Office Action Summary

10/517,997

DETAILED ACTION

Claims 1-4 are rejected under 35 U.S.C. 102(b) as being anticipated by Bellasio (US 3,863,861).

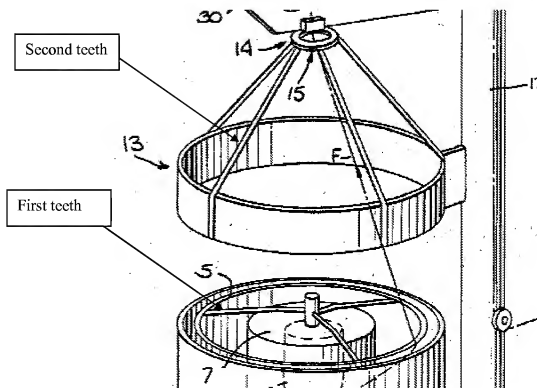
In regard to claim 1, Bellasio discloses a welding wire tangling-prevention device for preventing tangling of a welding wire (F) received in a large-capacity pail pack (4) in the form of a vertically-extending tube-shaped wound body including eccentrically-stacked continuous spiral loops, when the welding wire is drawn out from the pail pack (4), comprising:

a ring member (5,13,14) laid on a top surface of the tube-shaped wound body (Z), the ring member (5) including an outer ring (5) having an outer diameter smaller than an inner

diameter of the pail pack (4), and an inner ring (14) having an outer diameter smaller than an inner diameter of the outer ring (5);

a plurality of first comb teeth (Fig. 1, below) extending from an inner circumferential surface of the outer ring (5) toward the inner ring (14); and

a plurality of second comb teeth (Fig. 1, below) extending from an outer circumferential surface of the inner ring (14) toward the outer ring (5),

whereby the welding wire (F) is drawn out between the outer and inner rings (5, 14).

In regard to claim 2, Bellasio discloses the first comb teeth (see above) of the outer ring (5) have a length smaller than that of the second comb teeth (see above) of the inner ring (14).

In regard to claim 3, Bellasio discloses the first and second comb teeth (see above) are alternately arranged.

In regard to claim 4, Bellasio discloses each of the first and second comb teeth (see above) has a flat strip structure.
